**CITY OF HUTTO, TEXAS
ZONING BOARD OF ADJUSTMENT
REGULAR MEETING
Wednesday, August 28, 2019 AT 7:00 PM
CITY HALL - CITY COUNCIL CHAMBERS
500 WEST LIVE OAK STREET**

To: Zoning Board of Adjustment
Subject: Consideration of a public hearing and possible action on variance request #1.44 for the property located at 1500 Knowles Drive, Lot C3, Block J of the Enclave At Brushy Creek Section 1 Subdivision, from the bufferyard requirements as outlined in Section 10.403.6.3 of the Unified Development Code (UDC).
Meeting: Zoning Board of Adjustment - 28 Aug 2019
Department: Development Services
Staff Contact: Ashby Grundman

Variance request from the Bufferyard Requirement (10.403.6.3 of the UDC).

RE: KFC- Hutto, TX
1500 Knowles Drive

sheet number
A0.1
drawing type
permit
project number
19028

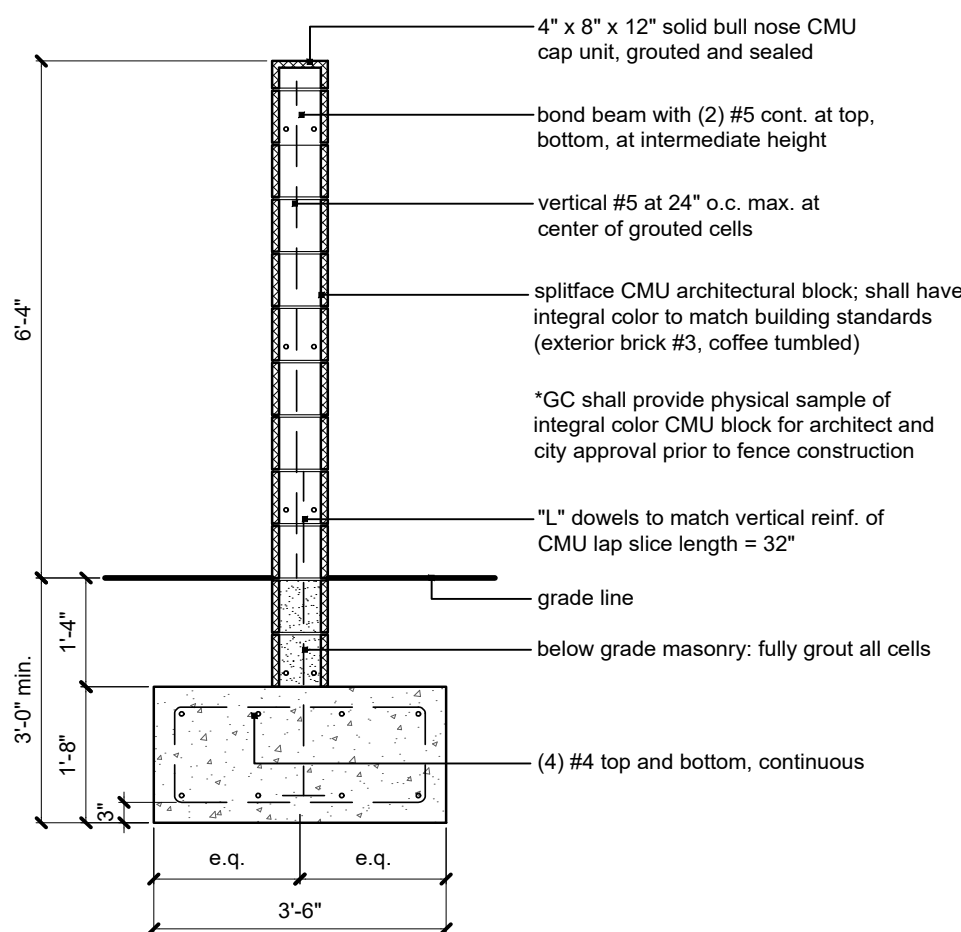
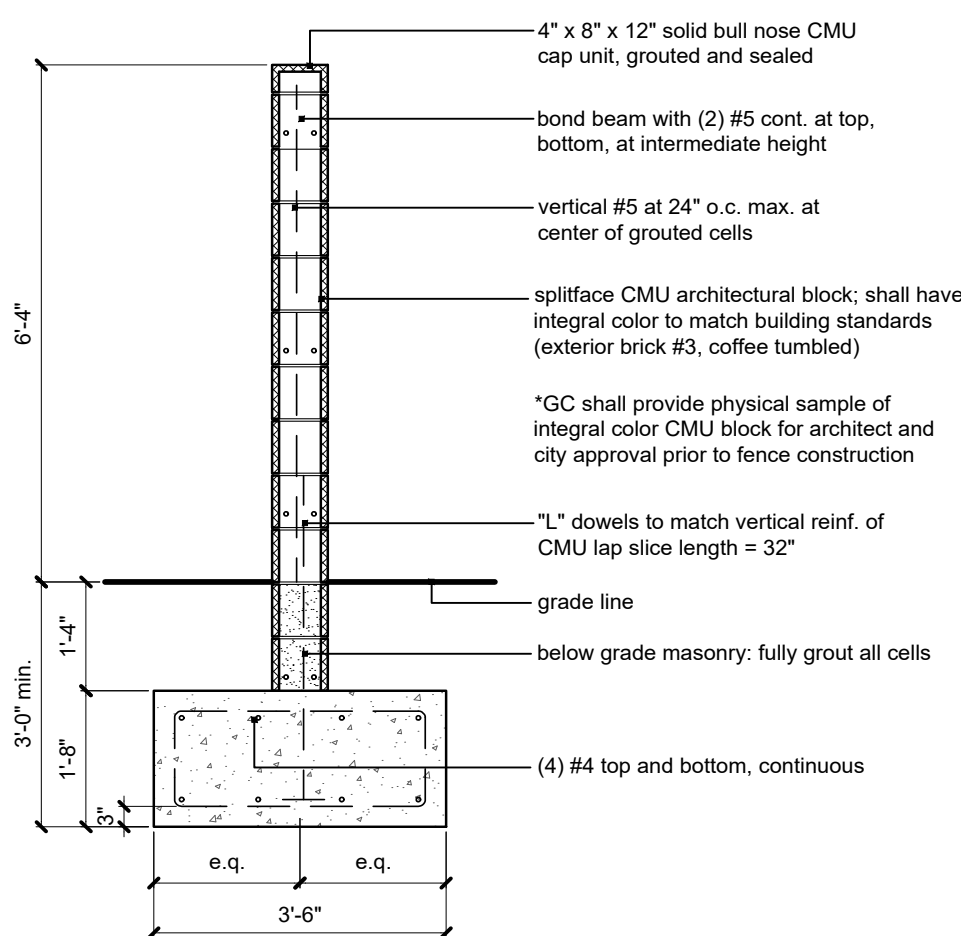
- Furnish and install continuous tubular steel ribbon bike rack to hold minimum 2 bikes.
- Furnish and install 6'-0" min. height masonry fence to extend approximately 221' per detail.

sheet number
A0.0
drawing type
permit
project number
19028

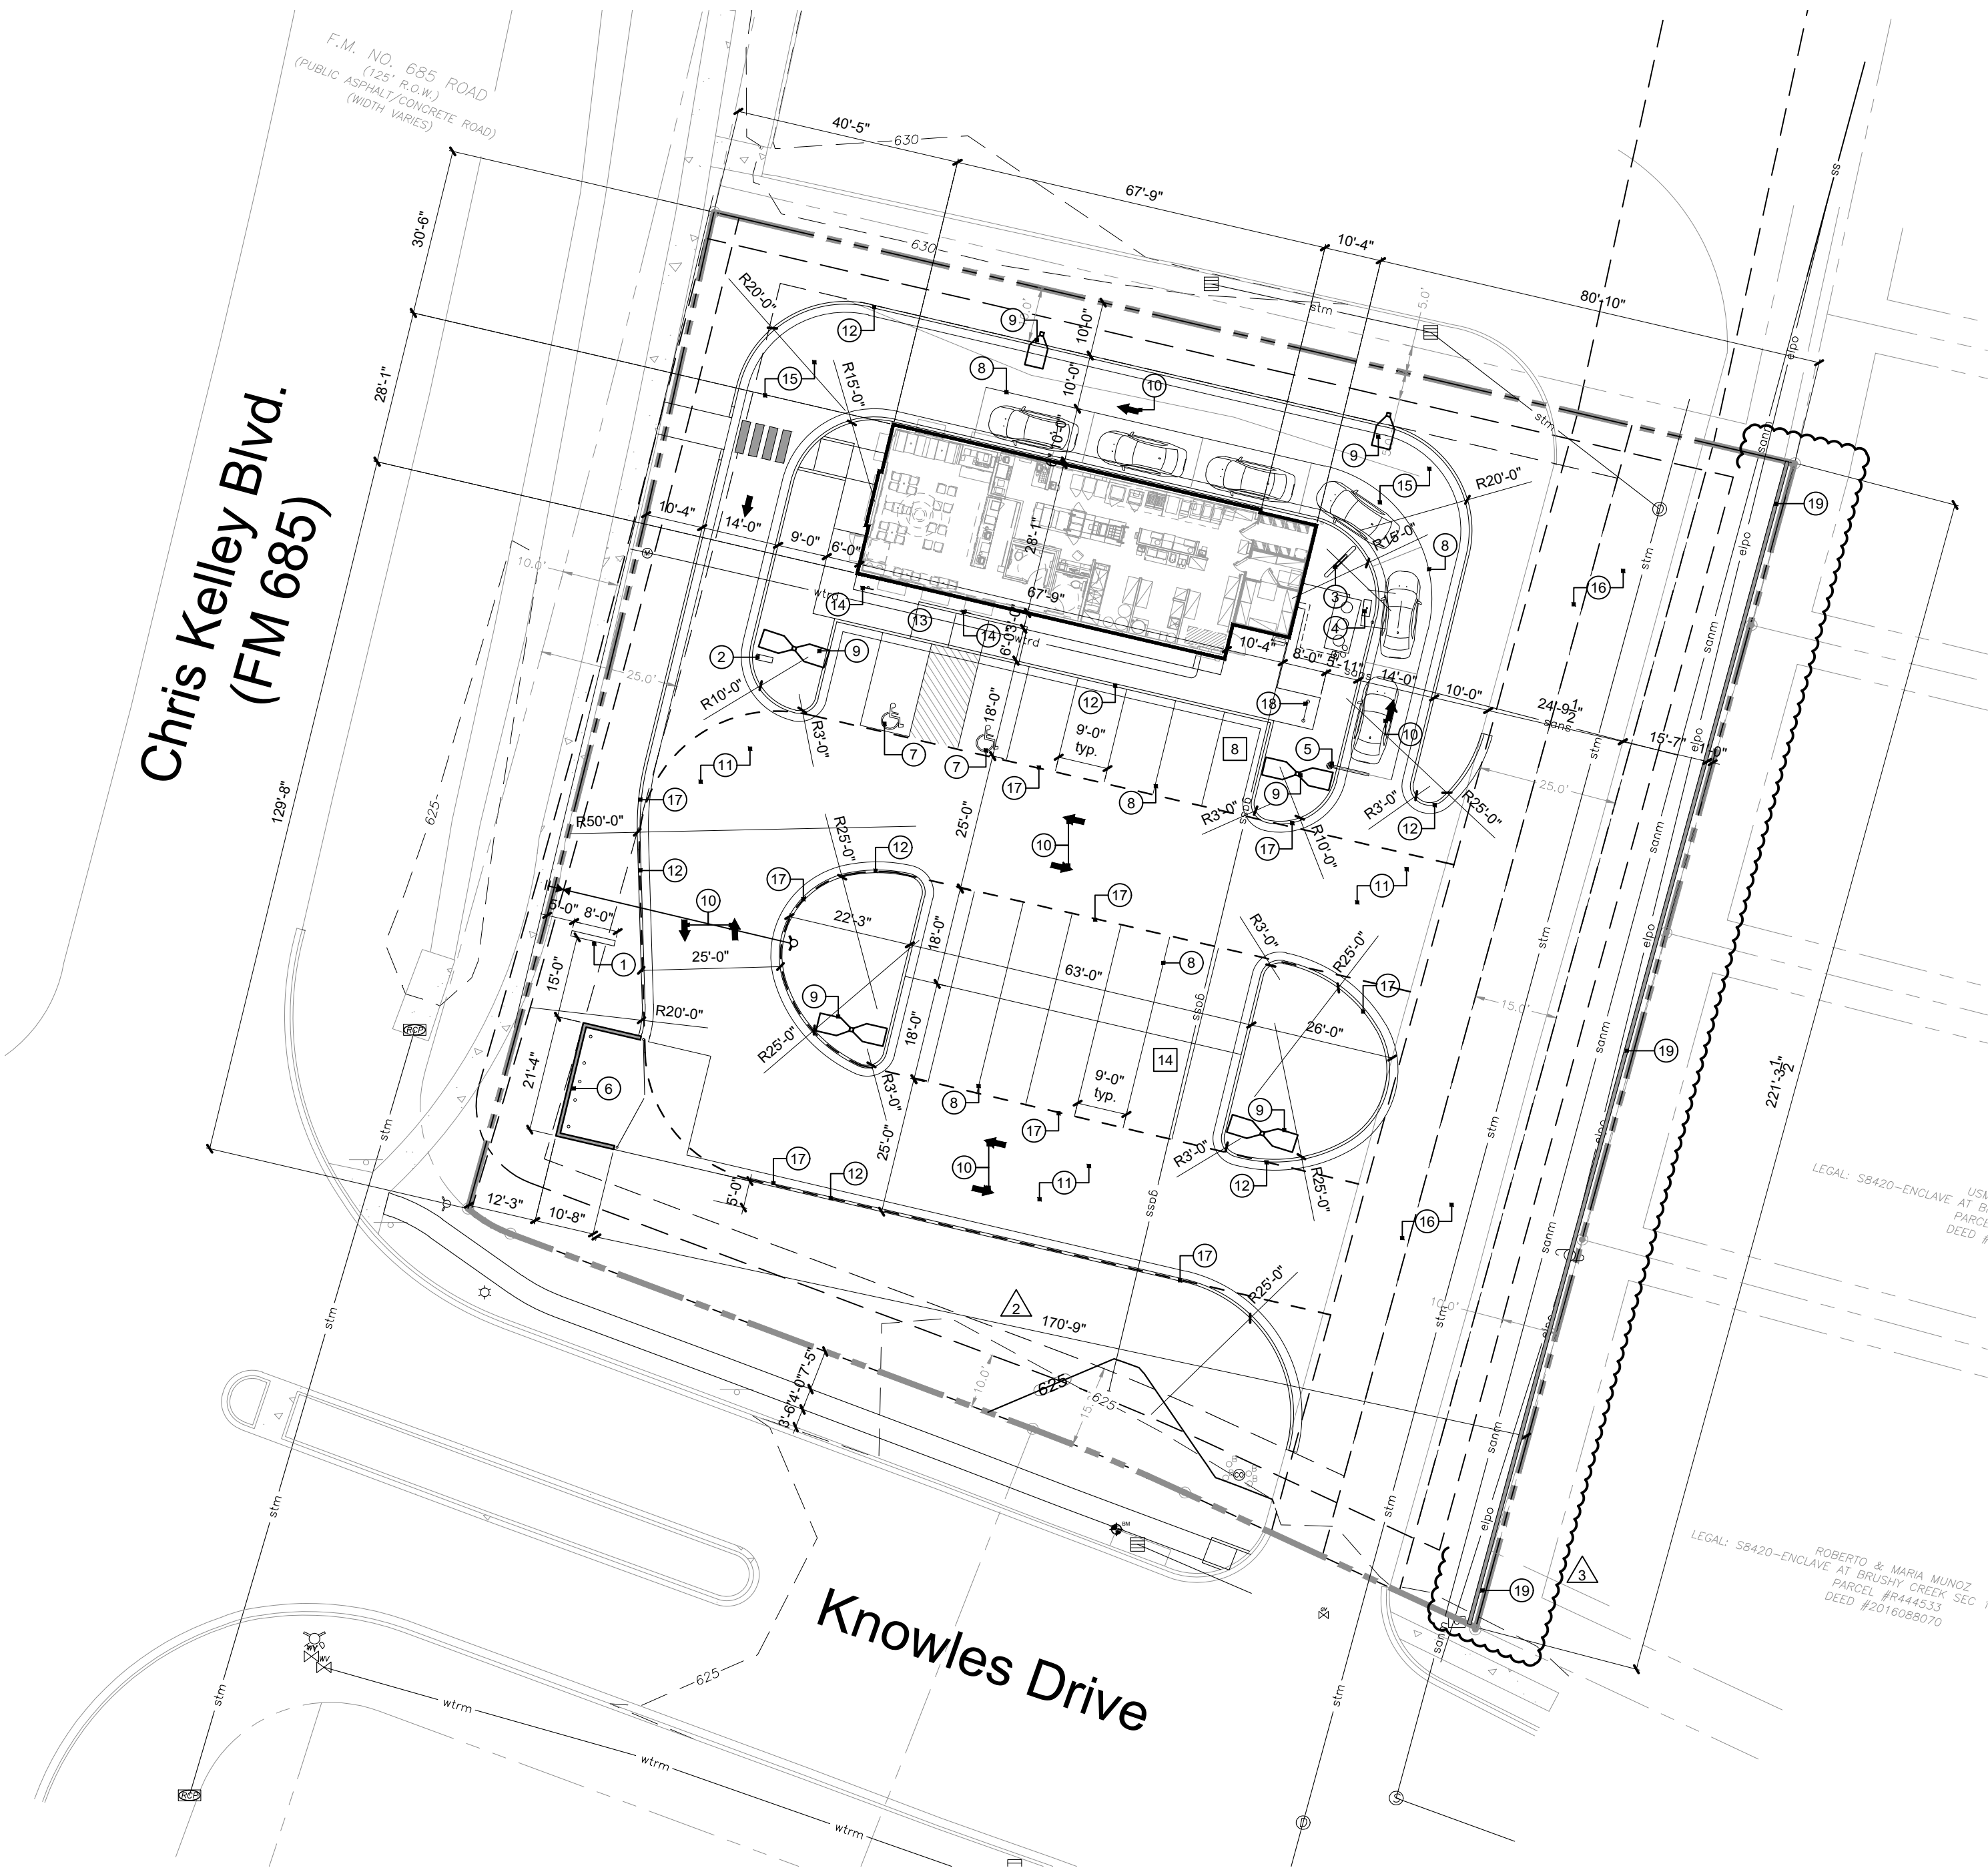
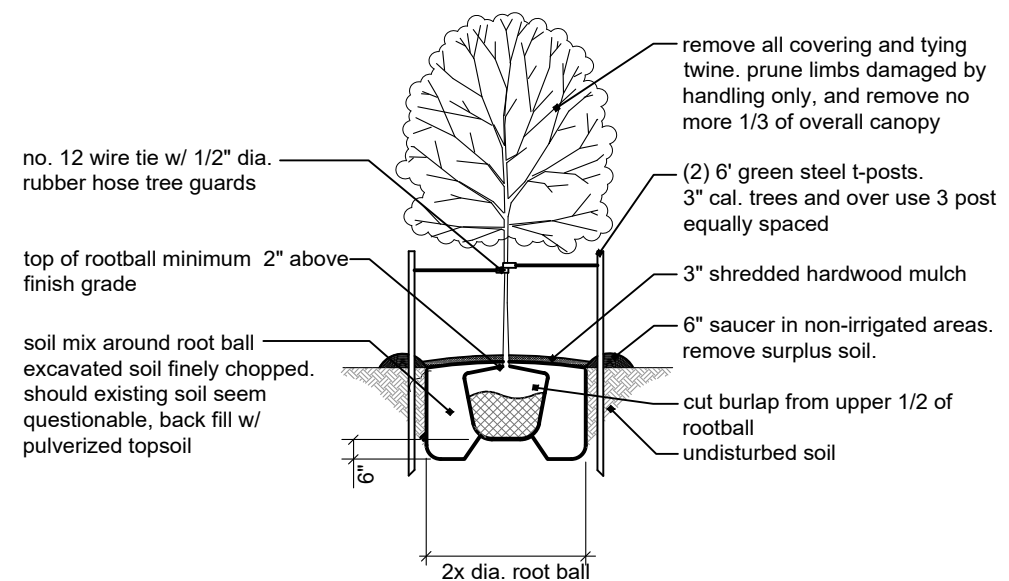
We are requesting variance approval to forgo the 6'+ masonry fence requirement along the east property line of the KFC development at 1500 Knowles Drive. Per Unified Development Code requirements, a buffer yard is required along the east property line of the KFC site (zoned B-2) and the adjacent residential property (zoned SF-1). The section in the Unified Development Code that is being reference is section 10.403.6.3 (C):

As the KFC site is designed, in coordination with planning staff, a total 26' of buffer yard is provided, refer to sheet A0.0. Through the center of the buffer yard is an existing 25' wide access drive connecting the adjacent north commercial property to Knowles Drive. Including the existing access drive, the back-of-curb at the drive-thru lane sets approximately 51'-0" from the east property line, which far exceeds buffer yard distance requirements. In coordination with planning staff we have increased landscaping to include dense buffer plantings on both sides of the existing access drive to achieve the 25' total buffer yard requirement.
